GOVERNMENT OF THE DISTRICT OF COLUMBIA
DEPARTMENT OF TRANSPORTATION

MEMORANDUM

SUBJECT: **BZA Case No. 19882** – 1724 Kalorama Road NW

Figure 1. Parking Occupancy Study Area (Source: Wells and Associates, On-Street Parking Restrictions, 10/19/18, Figure 6)

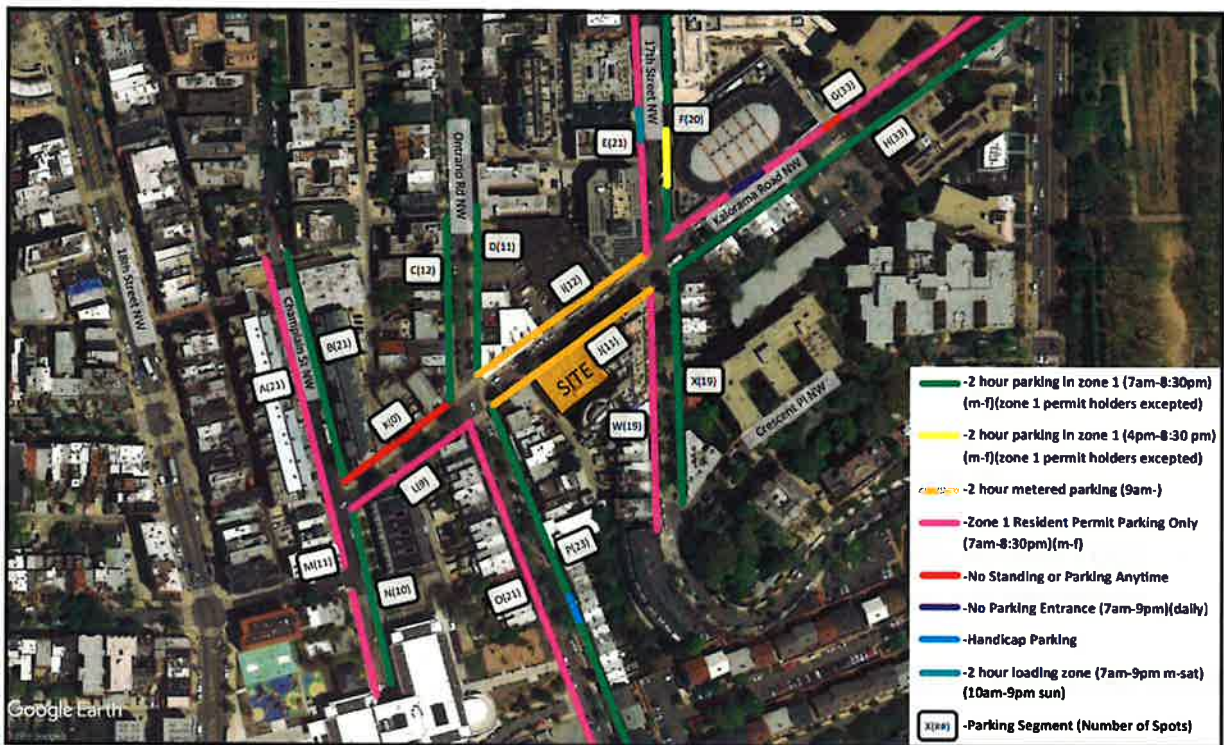
In situations where an Applicant is requesting relief from five (5) or greater vehicle parking spaces, DDOT typically requires an on-street parking occupancy study. The Applicant worked with DDOT to scope an appropriate area, as shown in Figure 1. Wells and Associates conducted an analysis of observed on-street vehicle parking conditions during weekday and weekend peak periods within a two to three block radius of the site. As shown below in Figures 1 and 2, the site is surrounded by on-street vehicle parking spaces.
